CONCEPTUAL DESIGN CONFERENCE SUMMARY & COMMENTS

Presented on June 5, 2017 by Hewitt Architects

ROSE HILL MIXED-USE | DRC CONSOLIDATED PACKAGE | APRIL 24, 2019

CONCEPTUAL DESIGN CONFERENCE CONCEPTS

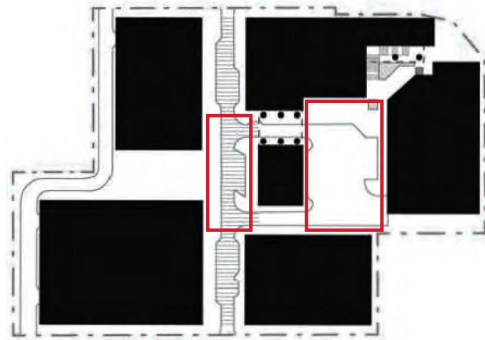
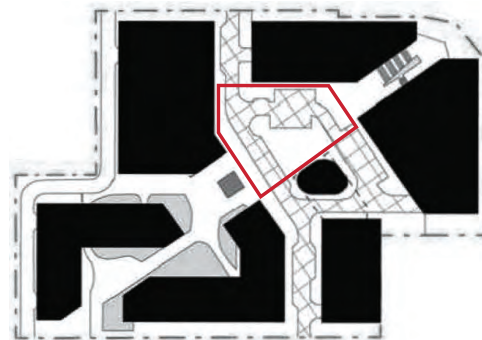
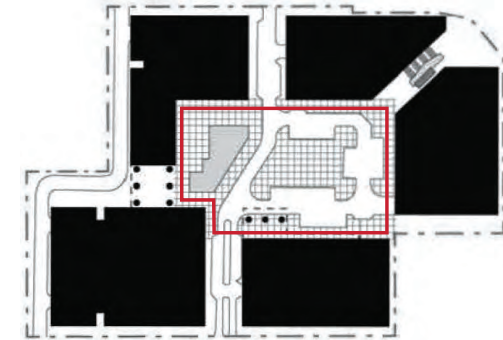
In general, the board appreciated the overall massing of the buildings. They would like to see further development of the north side and facade along 85th. They also encourage further development of the hub scheme design. The size of the hub scheme's open space seemed about right.

1 - DRB: Concern for the north facade and the height of the structure when viewed from the neighborhood to the north.	RESPONSE: The massing along the north side of the project has been carefully considered to no impose upon the adjacent properties. The building facades have been held back from the north property line approximate 45' to provide perimeter auto and pedestrian circulation and landscape buffering which minimizes the impact of the proposed buildings via landscaping and distance. In addition, the north building facades of building A and B have upper level step-backs, are broken into two separate buildings and provide generous modulation.
2 - DRB: Thinks the interior could be simplified with a diagonal piazza or simpler shape at the interior.	RESPONSE: Previous DRB deliberations favored the size of the Hub Scheme while preferring the well defined, strong form of the Piazza Scheme. Our proposed plaza configuration is a well-defined rectangular space that has been divided into distinctive automobile and pedestrian plazas. The space is well organized and easily comprehended which aids in clear circulation with a central focus.

3- DRB: Food services from the grocery store could engage 85th, ensure activation happens along 85th.	RESPONSE: Activation of the SE corner terraces and entrance stairs is very important to the success of the pedestrian access to the intersection. The grocery mezzanine will likely include a food service dining area, is positioned to spill out onto one of these mid-level terraces. The 85th street frontage will be well engaged via a continuous clerestory storefront which looks down into the grocery store. The east end of this frontage will provide a commercial space and a residential entrance/ lobby which is well-connected to the SE corner plaza.
4 - DRB: The abruptness of the approach to U-Haul, may also be an issue. We want to make sure that we don't end up with a very abrupt wall here, which is along 85th.	RESPONSE: Any previous abruptness between the building mass along 85th st. Relative to the U-Haul site, has been mediated by bifurcating our south facade into two buildings. In addition, the west elevation adjacent to u-haul of our residential massing has been held back from the property line and broken into two distinct building masses. This variation in facade design and orientation helps provide visual interest adjacent to the U-Haul Property.

5- DRB: Would like to see how the long walls will be modulated and/or broken up along 120th and 122nd.	RESPONSE: The previous scheme's long walls along the east and west elevations have been broken into more equal lengths, as well as been well modulated into distinctive facade types.
6- DRB: How will pedestrians like kids travel through the site? It's clear that the east is friendlier than west.	RESPONSE: Pedestrians well access and travel through the site via well defined access points. The southeast corner plaza will invite the visitors with a generous and well organized sequence of terraces connected via a grand stair. Entrance drives with generous sidewalks and landscaping will connect both 120th and 122nd Street's to the interior plaza. The need for any exterior circulation between the northwest in northeast side corners isn't relevant to off-site or on site circulation.
7 - DRB: The dilemma is that the project faces inward. I'm going to encourage the applicant to also face outward along 120th & 85th, in the same way that happens along 122nd.	RESPONSE: The previous scheme fronted parking garages along both 120th and 122nd. This exposed parking garage layout has been eliminated. The 122nd street elevation now provides street level commercial to residential entrance lobby's, with some residential units buffered by landscaping. The 120th street elevation now provides street level health club storefronts and residential entrances. Both 120th and 1202nd now provide pedestrian oriented frontages which provide an interesting and active walk and experience.

8 - DRB: I'm not sure that the Costco is a destination, or that the pedestrian pathway needs to extend all the way to the north. Signalization will be required at some point in the future.	RESPONSE: The existing pedestrian crosswalk will likely need to be relocated to provide direct access from the Costco store to the remaining Costco parking opposite 120th st. Whether signalization is necessary is yet to be determined.
9 - DRB: Residential uses at the ground floor should be encouraged along the sidewalks at both 120th & 122nd. Would like to see ground floor connections with section or elevations.	RESPONSE: Please see previous response regarding project facing outwards towards 120th and 122nd streets.
10 - DRB: Would like to see some of the clarity of the strong interior piazza form brought into the hub scheme, through the use of paving, landscape material, and edges of buildings.	RESPONSE: The strength of the previous interior piazza scheme was in the clarity of it's geometric space. Unfortunately, the development of the parking and pedestrian areas appeared very suburban and reminiscent of the strip retail center. Comparatively, we have reduce the size of the plaza, defined distinctive automobile versus pedestrian areas, and suggest clearly defined circulation patterns and casual seating areas, separated by generous landscaping. Please see the illustrated site plan.

11 - DRB: Definition of the outdoor room configuration is important. Sun exposure is important to preserve along the north edge of the grocery store, and the massing of the housing above.	RESPONSE: The central plaza is well defined by the adjacent commercial spaces, with the pedestrian implies a space appropriately scaled to appear well utilized and active. The upper residential facades are stepped back from the commercial massing to provide a secondary upper plaza scale which affords generous sunlight. The upper residential mass along 85th ST is divided to provide excellent midday sun exposure. The pedestrian plaza as well as the north grocery frontage will be an excellent outdoor experience.

SUMMARY OF CDC COMMENTS

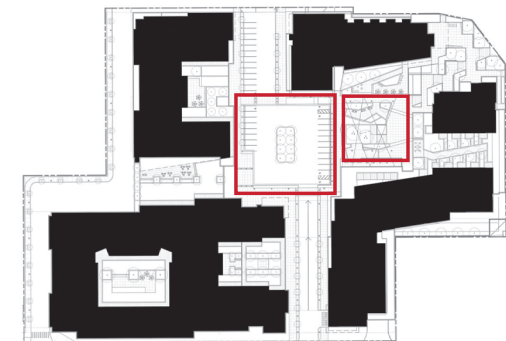
- Height of structure when viewed from the North.
- Interior of plaza should not be complex.
- Food services from grocery could engage 85th, activation is important.
- Entrance to U-Haul should not be too abrupt from 85th.
- Long walls along 120th and 122nd should be modulated.
- Travel through the site should be clear and friendly.
- We are encouraged to have the project face both inward and outward.
- Residential uses at sidewalk should be encouraged along 120th and 122nd.
- Strong interior plaza form is positive.
- Sun exposure to interior spaces is important.
